STAFF REPORT: NOVEMBER 12, 2025 MEETING
APPLICATION NUMBER: HDC2025-00498
ADDRESS: 3768 TYLER

HISTORIC DISTRICT: RUSSELL WOODS-SULLIVAN HISTORIC DISTRICT
APPLICANT: STEPHEN WASHINGTON, GRANDIOSE REAL ESTATE SOLUTIONS LLC
PROPERTY OWNER: GRANDIOSE REAL ESTATE SOLUTIONS LLC
DATE OF PROVISIONALLY COMPLETE APPLICATION: 10/17/25
DATE OF STAFF SITE VISIT: 9/15/25; 10/24/25

SCOPE: INSTALL FRONT PORCH NEW GUARDRAIL, REBUILD GARAGE ROOF, REPAIR GARAGE'S CONCRETE BLOCK WALLS, REPLACE GARAGE HINGED DOOR AND OVERHEAD DOORS

Drawing from applicant's materials, showing the existing pier/post on the left, the rebuilt pier to the right, next to the tall column, and the new proposed guardrail. Also shown are new matching handrails on both sides of the front steps.

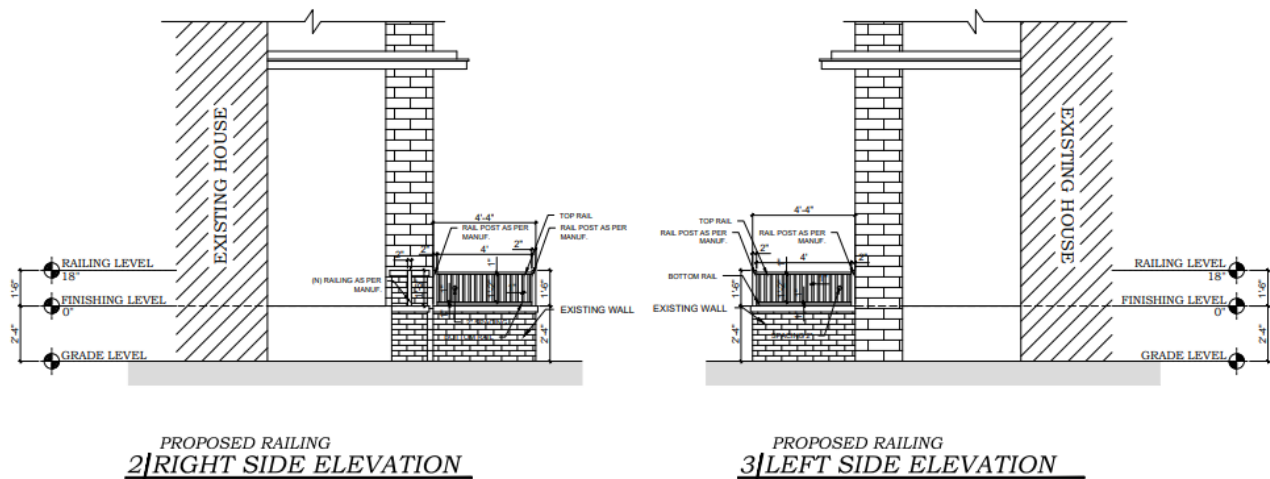
- Proposed, instead, is to: remove the curved masonry insets that had stone coping and that held the front porch guardrail; build a replacement porch pier next to the porch's center column that matches the porch pier at the southwest corner of the house; and install a new, simple, aluminum rail in black between those two square piers. The result would be brick features that are similar to the porch piers that hold the second-floor guardrail, but with a simpler guardrail on the first floor. The Secretary of the Interior's Standards and Guidelines for Rehabilitation would allow for a compatible replacement rail to be installed if the missing historic feature was unknown and undocumented, but that is not the case here.

- The proposed rail is simple, black, custom-welded aluminum, and 18" tall like the balcony guardrail. Worth noting is that the drawing shows the existing square brick pier at the house's southwest corner as just slightly taller than the 18-inch railing, but that is not actually the case. The existing brick pier is taller than shown on the drawing because the existing curved masonry inset tapers in height to meet the 18-inch rail, and that feature has been removed in the drawing. The second-floor brick piers/columns stand quite a bit taller than the 18-inch rail on the balcony, and that relationship, as proposed, would be similar at the first floor as well.

- The character-defining features around the first-floor front porch include the decorative brickwork above and below the porch. Because the brick and stone details below the porch are coordinated with the curved masonry insets that held the original iron guardrail, retaining those curved inset sections (instead of removing them as proposed) and duplicating the historic rail would meet the Secretary of the Interior's Standards for Rehabilitation.

- To meet the Secretary of the Interior's Standards for Rehabilitation, the front porch guardrail should be duplicated from the balcony guardrail, and the curved masonry sections that originally held the guardrail should be preserved, along with the other masonry details above and below the front porch.

- the applicant will submit corrected front porch drawings for staff review and approval that preserve the historic, character-defining features including the curved masonry sections between the brick column and pier and the brick and stone details below the front porch concrete cap, and the applicant will duplicate the missing porch guardrail based on the historic second-floor balcony guardrail.
- the applicant will submit corrected garage elevation drawings for staff review and approval that accurately reflect the proposed design.
- product cut sheets for the garage doors (both overhead and service doors) and any garage window will be submitted to staff for review and approval before the work begins.

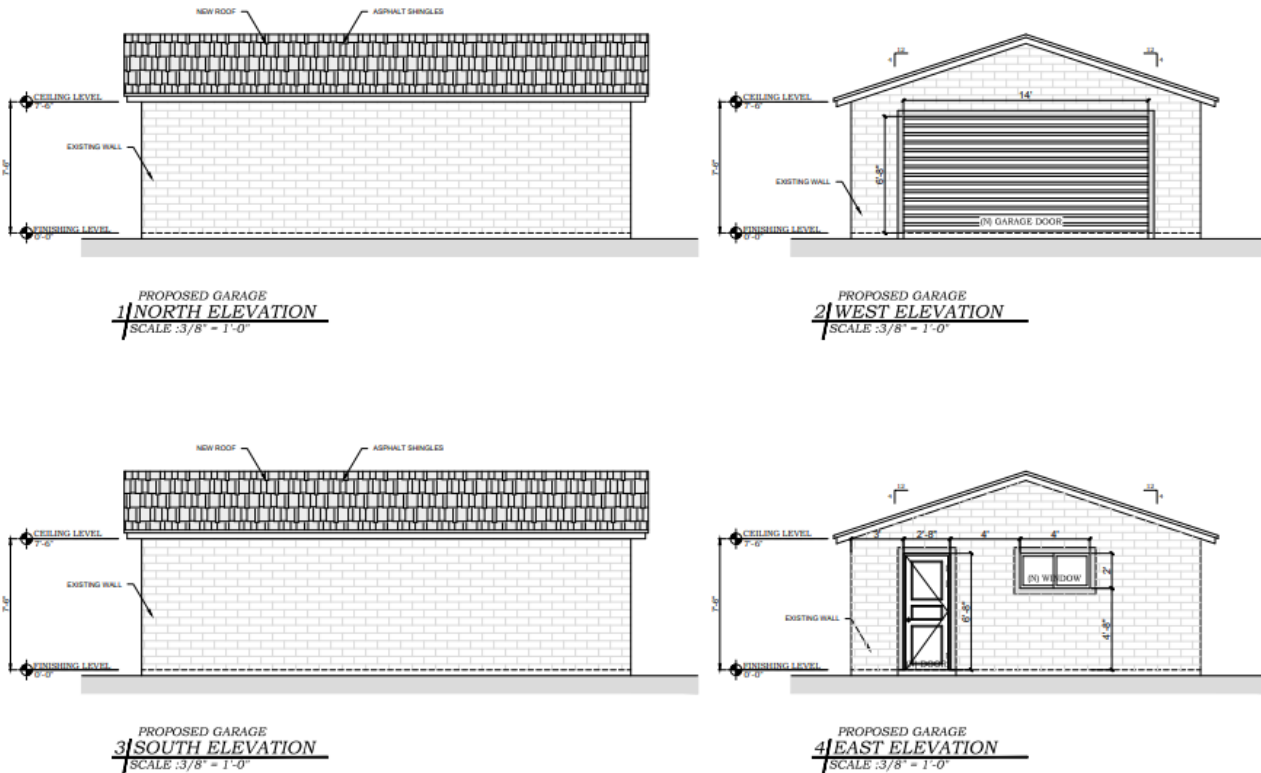
Drawing from applicant's materials showing repaired garage with rebuilt roof. Replacement garage doors and window products have not been selected. Staff believes these elevations are mislabeled. The longer sides should be west and east elevations and the shorter ends should be north and south. If the former roofline will be reproduced, the gable ends should be on the long sides (the west and east).

- The applicant has indicated that his plan is to rebuild the garage as it was, with the same footprint, height, and roof pitch, but the elevation drawings do not seem to indicate that. Staff believes them to be mislabeled and is unclear as to which direction the proposed gable roof will be oriented.

- Because product cut sheets for the garage doors (service and overhead) were not provided, staff recommends that if approval is to be granted, the commission give staff authority to review and approve the final door selections.
